Manual Supplement

Manual Title:	PS320 Users	Supplement Issue:	**4**
Part Number:	2631693	Issue Date:	9/17
Print Date:	April 2006	Page Count:	3
Revision/Date:	1, 12/07

FLUKE.
Biomedical

On page 19, add the following ***Battery Replacement*** section:

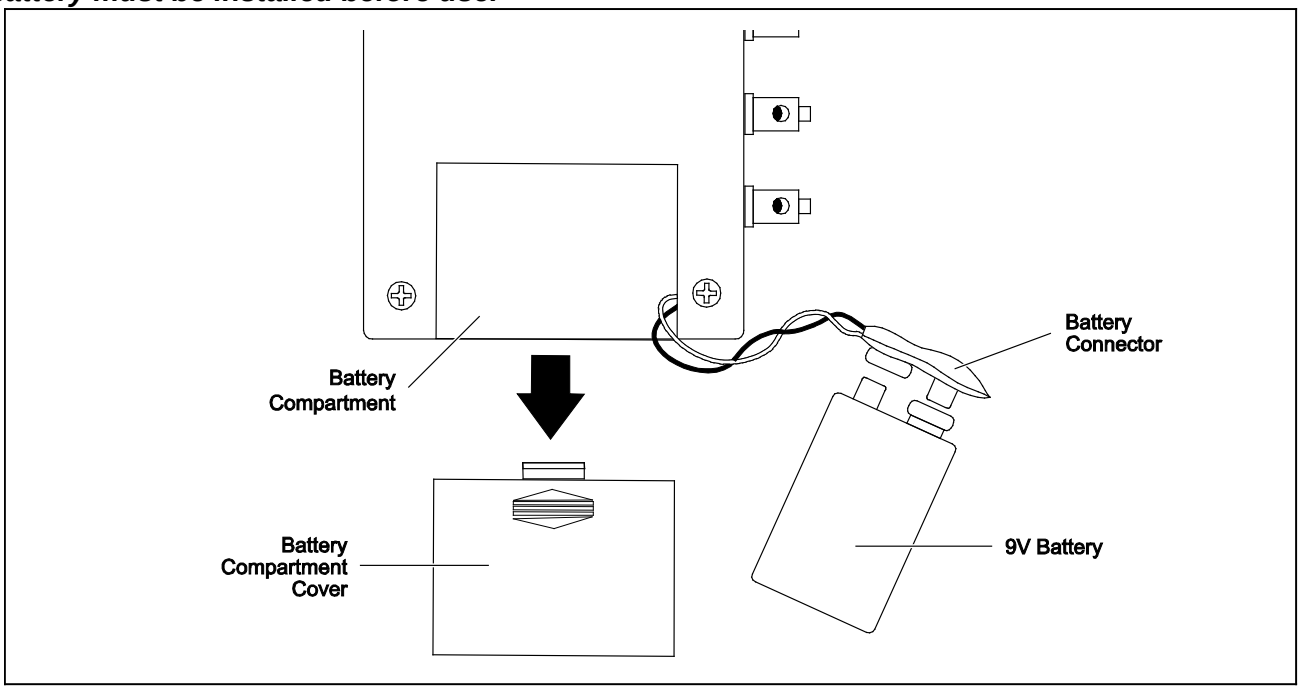
Change #4, 505

9V battery must be installed before use.
